SUBJECT: Forwards response to RAI re review of request for amend dtd 970929 for TS related to main steam line isolation signal setpoints.

Subject: Response to Request for Additional Information (RAI)
Rochester Gas & Electric Corporation
R.E. Ginna Nuclear Power Plant
Docket No. 50-244

Reference: Letter from G.S. Vissing, NRC, to R.C. Mecredy, RG&E, Subject: *Request for Additional Information - Review of Request for Amendment Dated September 29, 1997 - Change to the Technical Specification Related to the Main Steam Line Isolation Signal Setpoints (TAC No. M99702)*, dated April 3, 1998.

Response to RAI of April 3, 1998

Figure 4

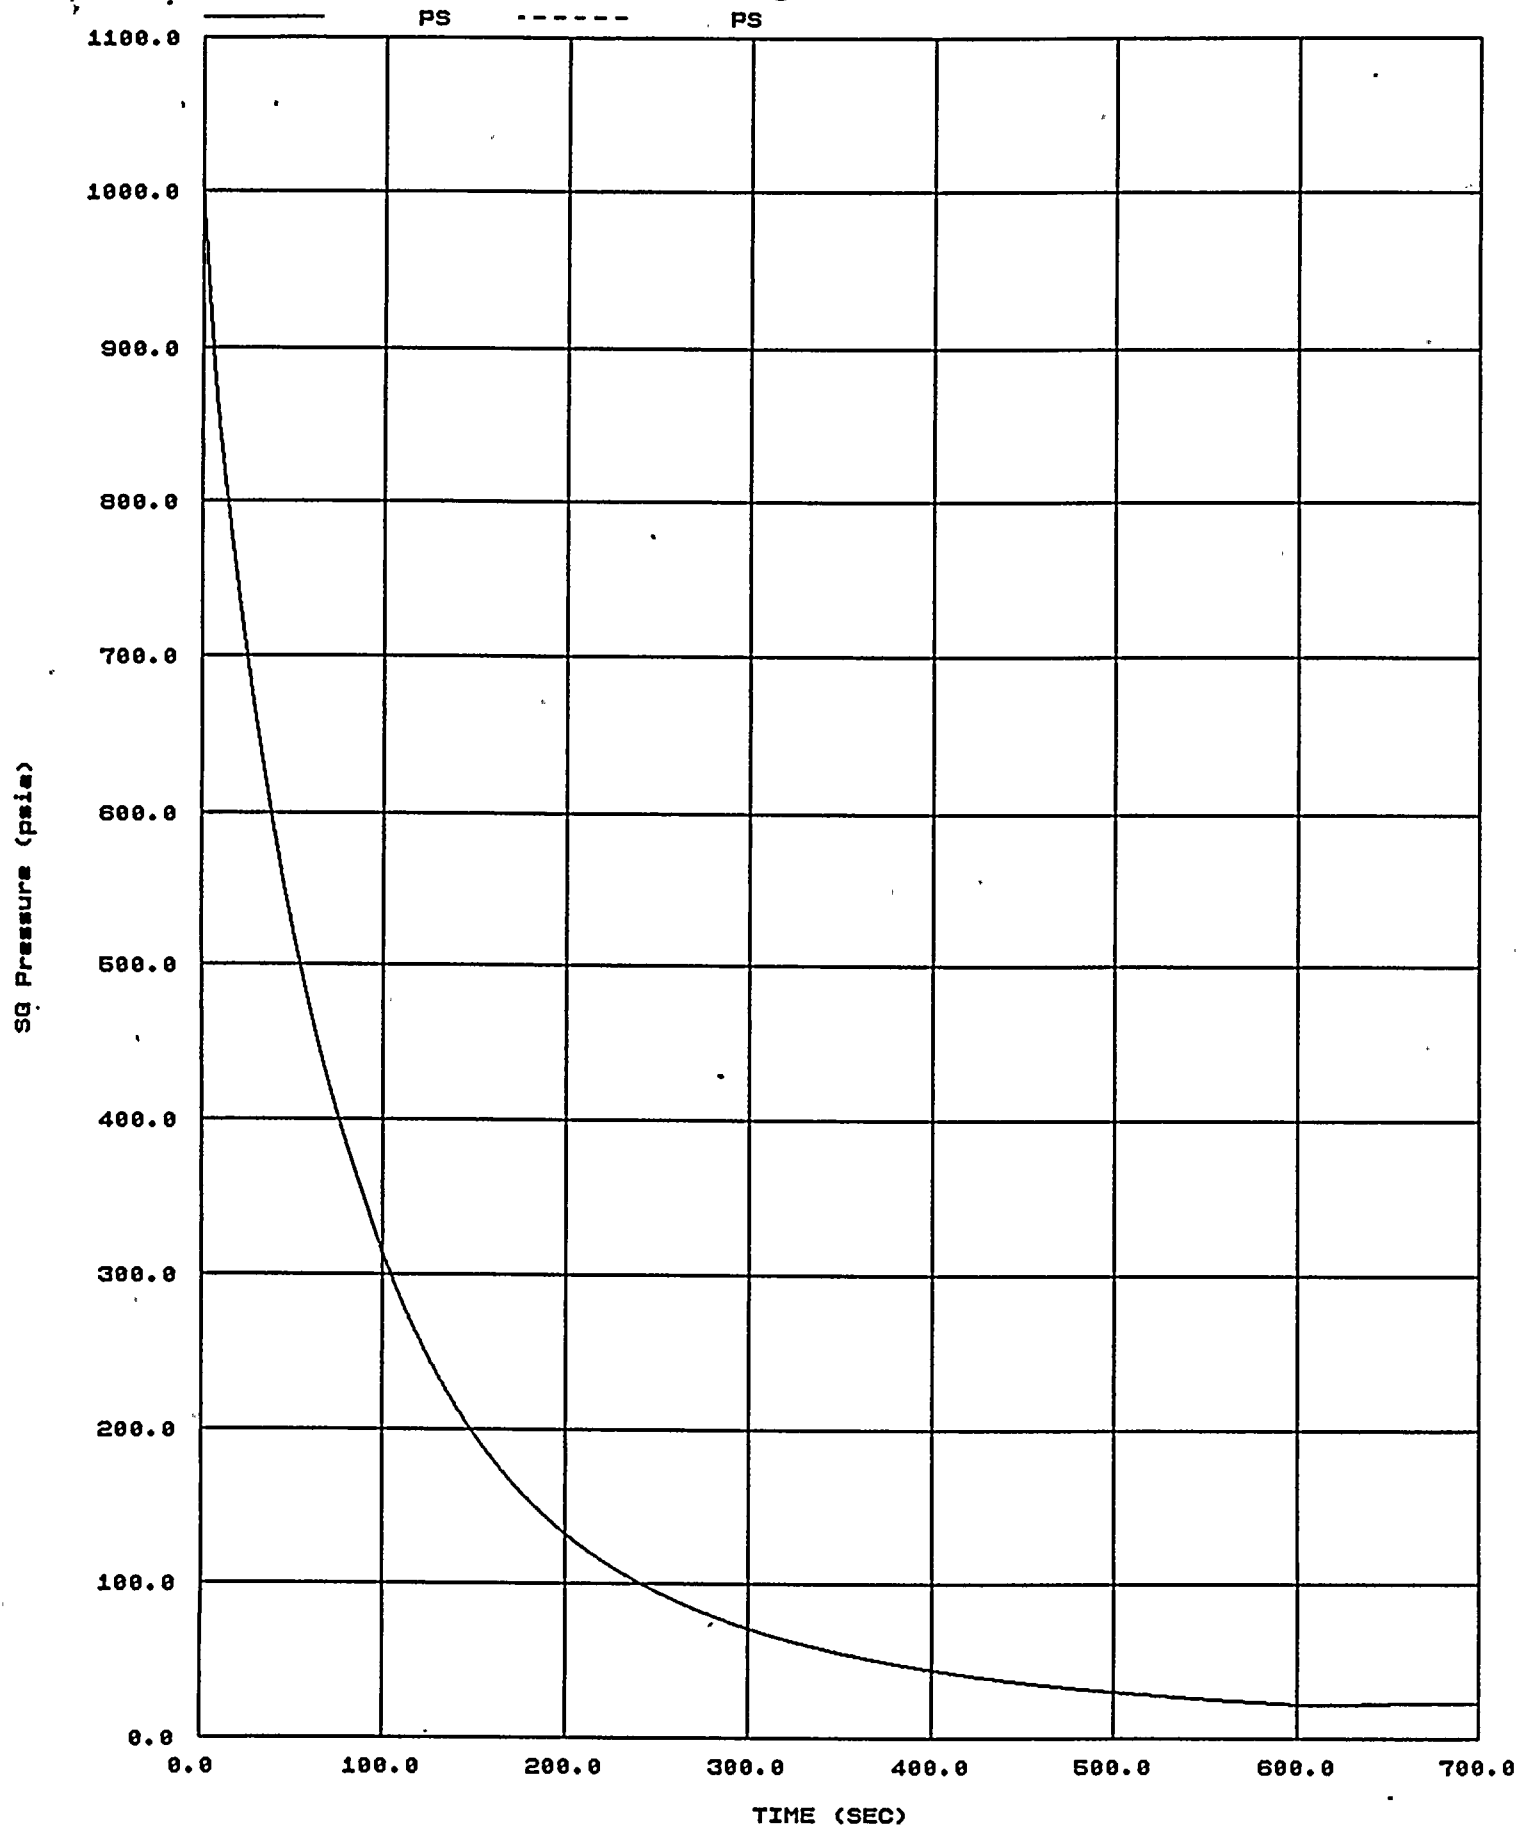
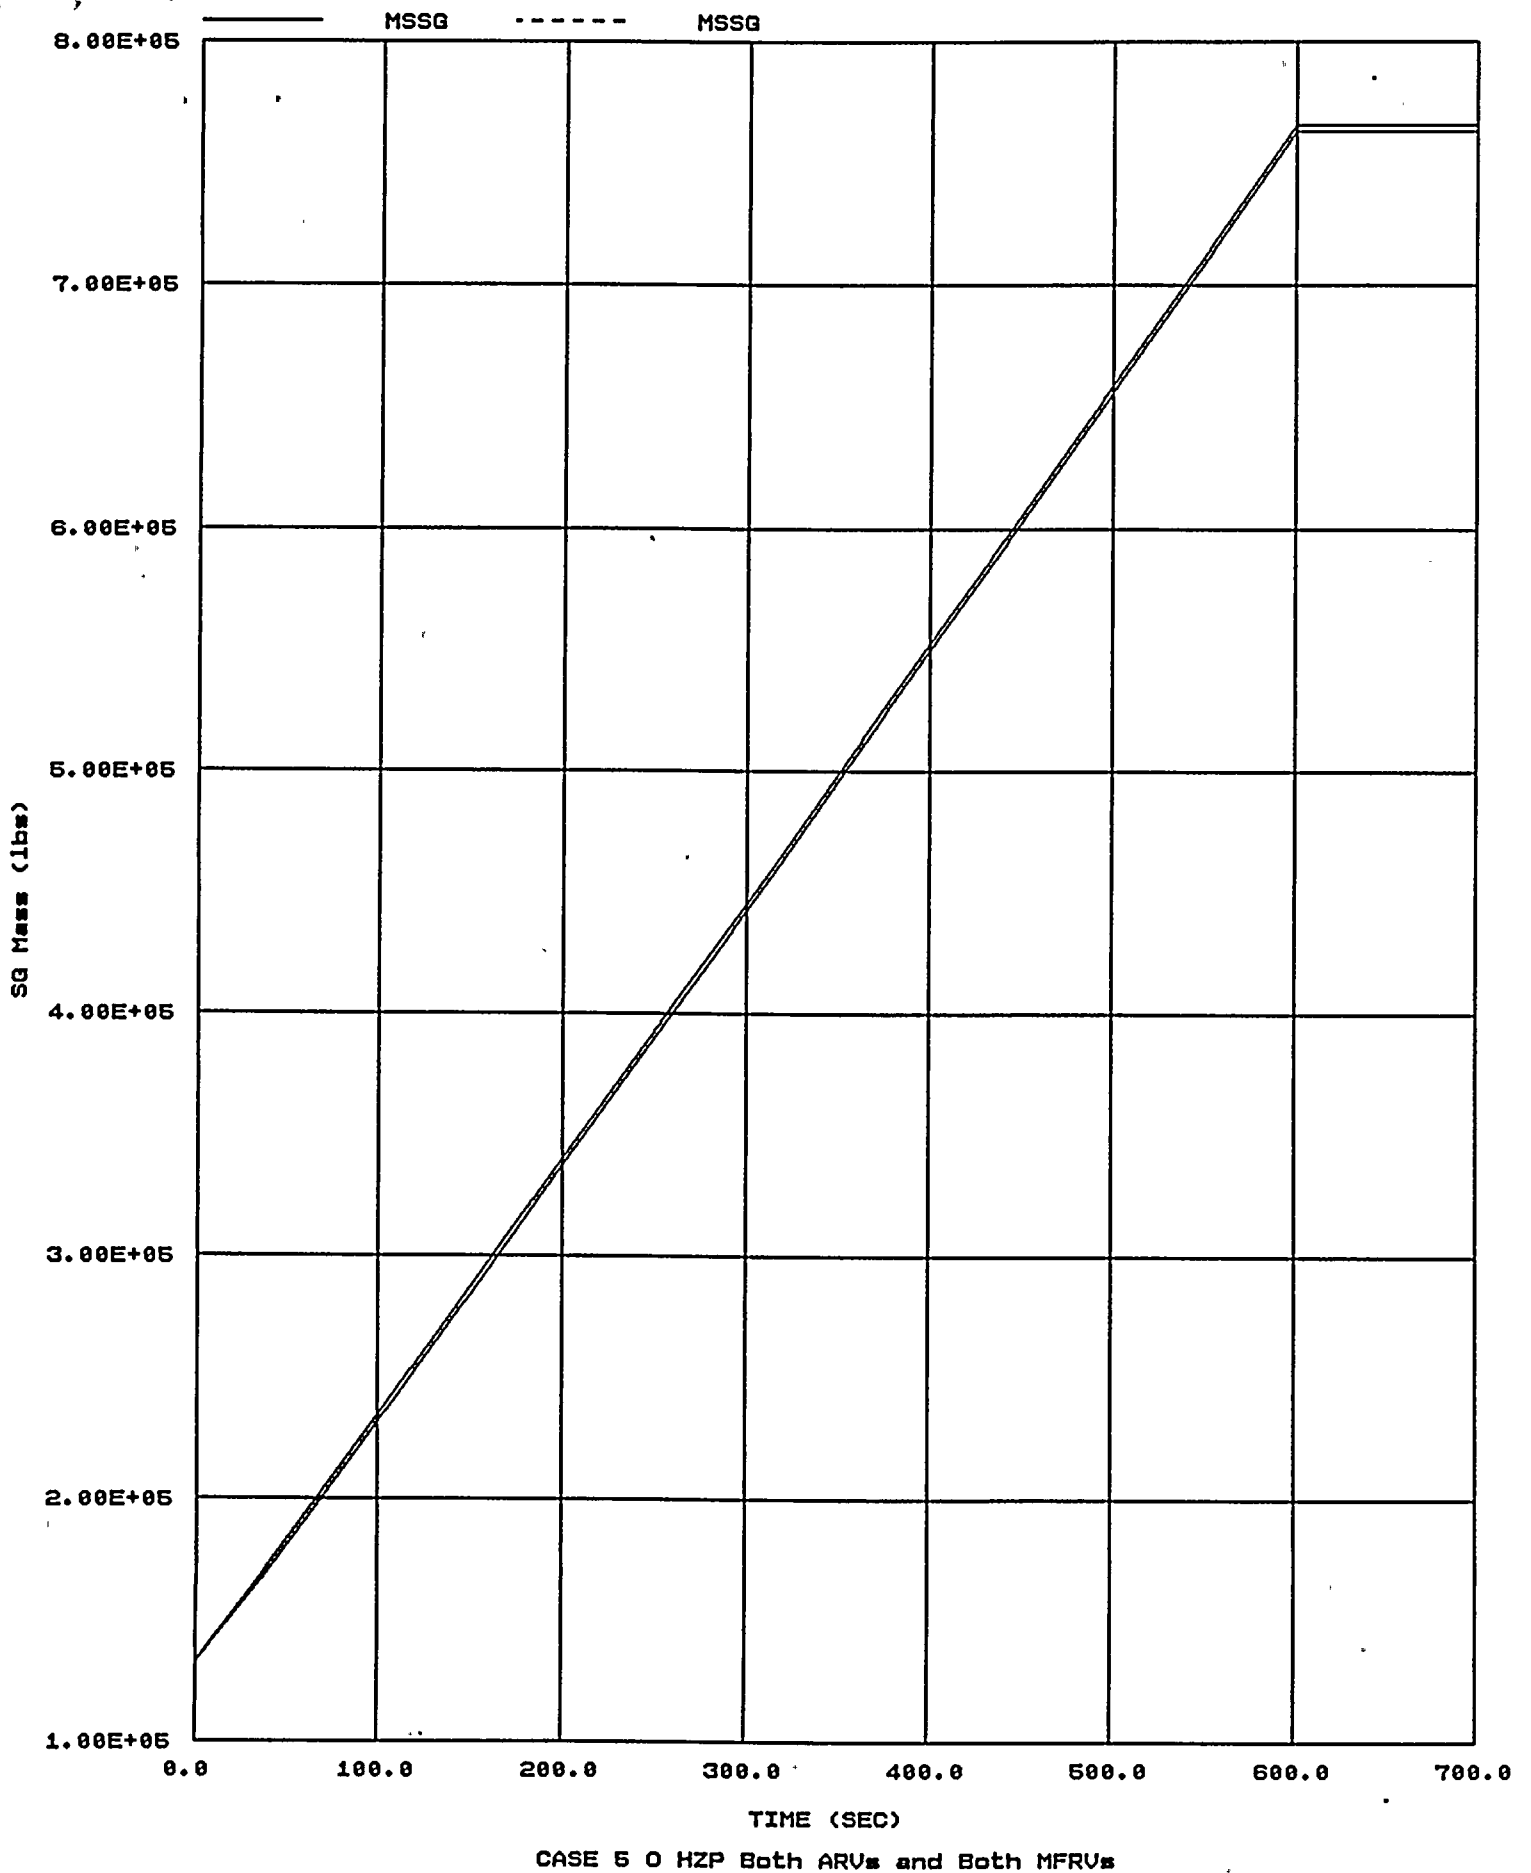
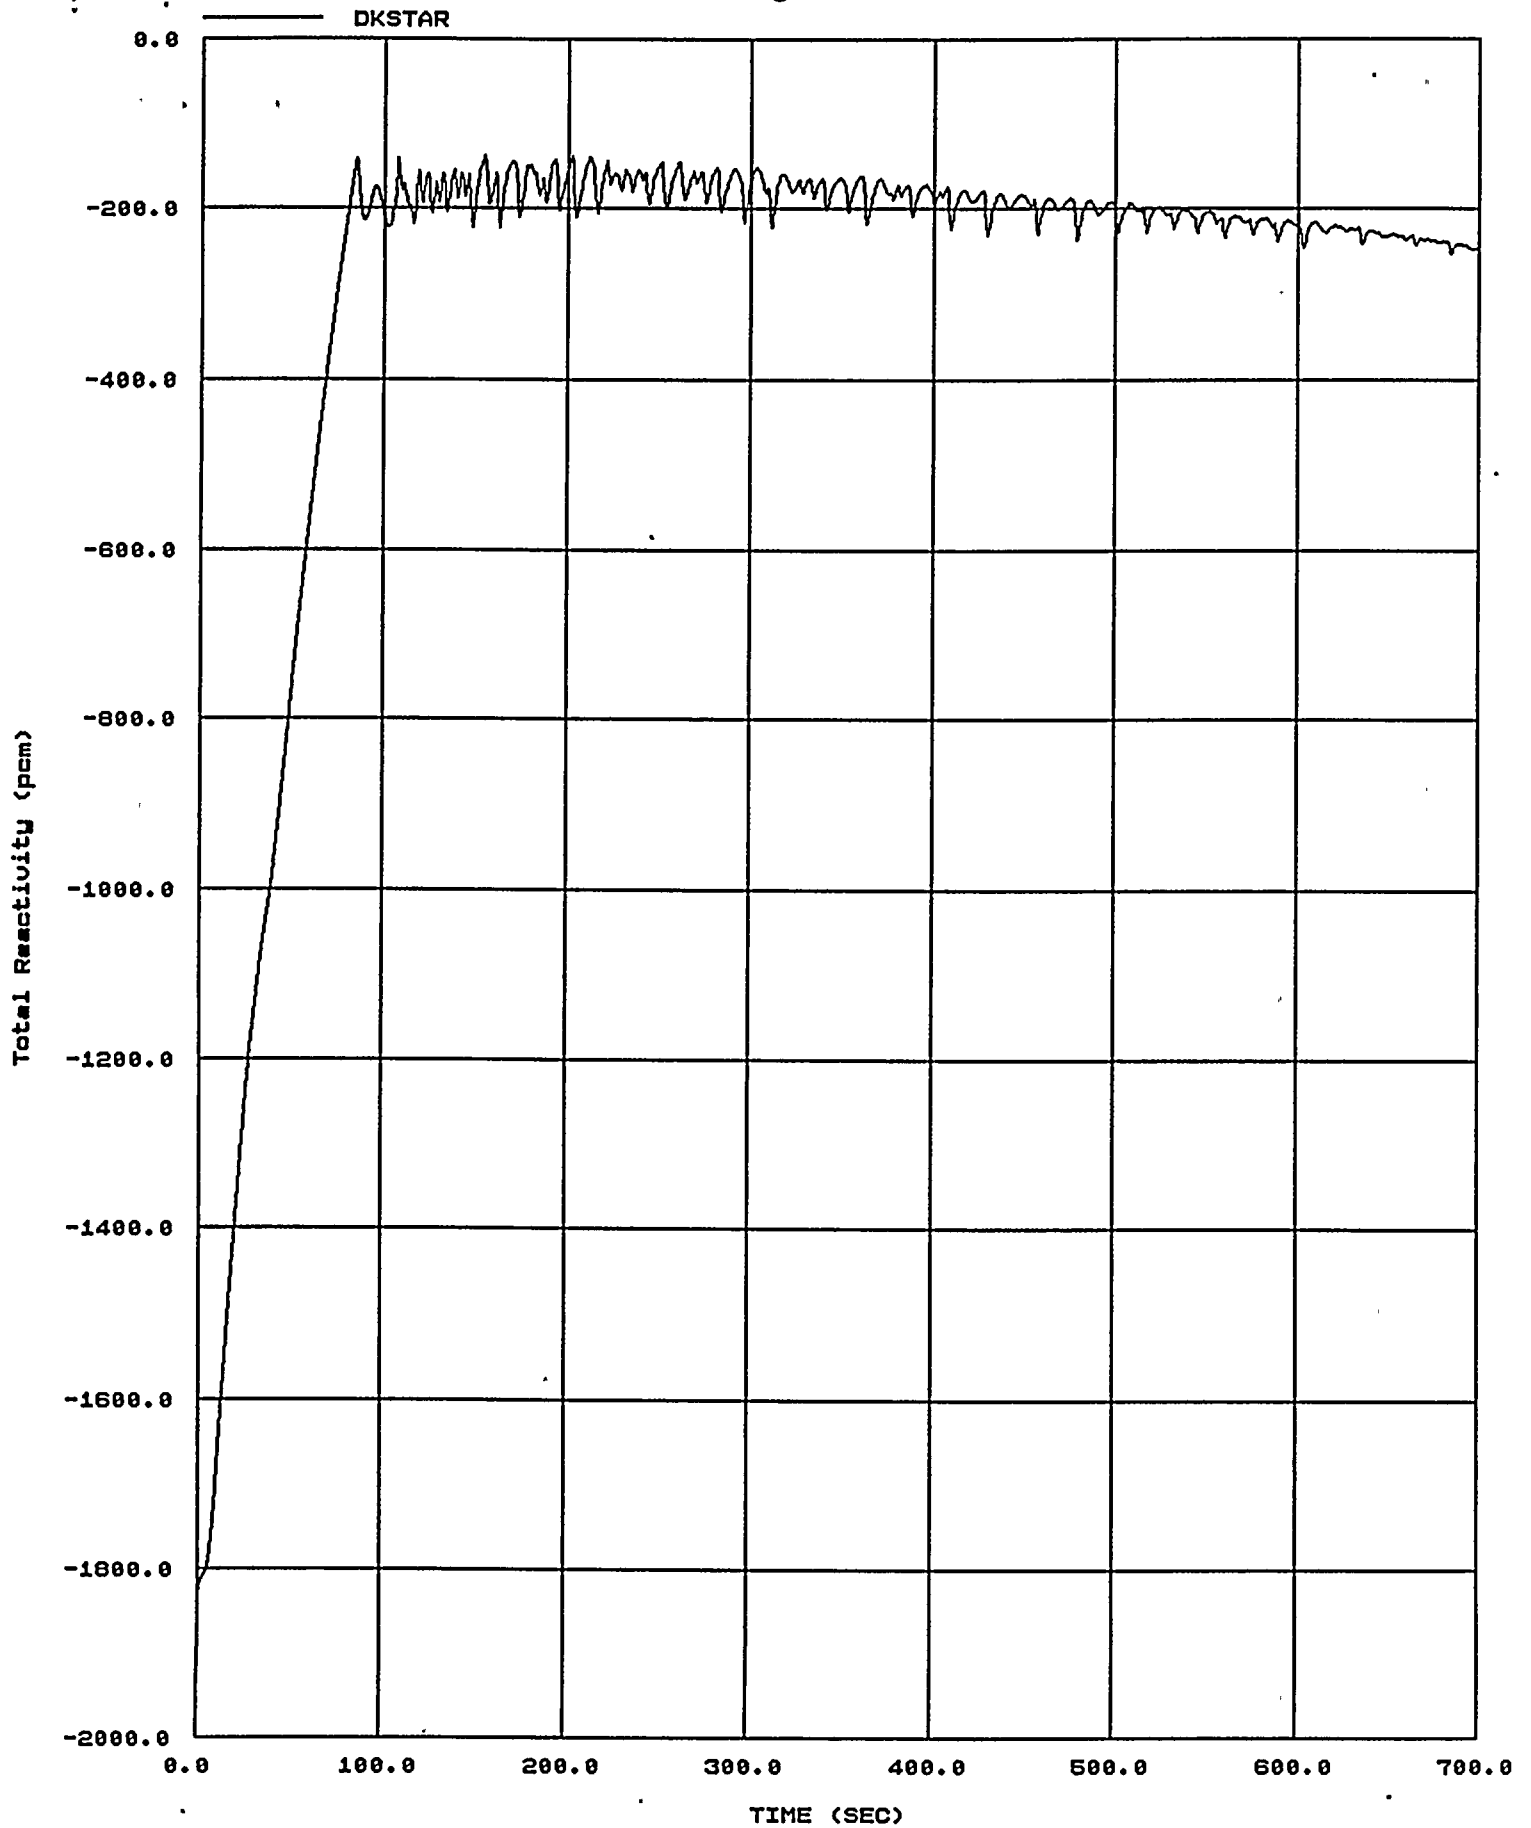
2. *Please provide the results of your reanalysis.*

Attached Figures 1 through 7 represent parameters from Case 5-O. Figures 8 through 14 represent parameters from the 0.66E6 lbm/hr steam line break in one steam generator described in the February 6, 1998 RG&E letter (hereafter referred to as Case SLB). A comparison of the parameters shows:

- a. Resulting nuclear power is less for Case SLB;
- b. Resulting RCS temperature reduction is less for Case SLB;
- c. Resulting pressurizer pressure reduction is less for Case SLB;
- d. Resulting steam generator pressure reduction is less for Case SLB;
- e. Steam generator mass trends illustrate the difference between a feedwater malfunction and a steam break;
- f. Total reactivity insertion is less for Case SLB but occurs over a longer time frame; and
- g. The rate of reactivity insertion is less for Case SLB.

In summary, the parameters indicate that the Case SLB is less severe than Case 5-O and that the limiting criteria with respect to the reactivity insertion rate is less than that for Case 5-O. Therefore, UFSAR Case 5-O remains bounding.
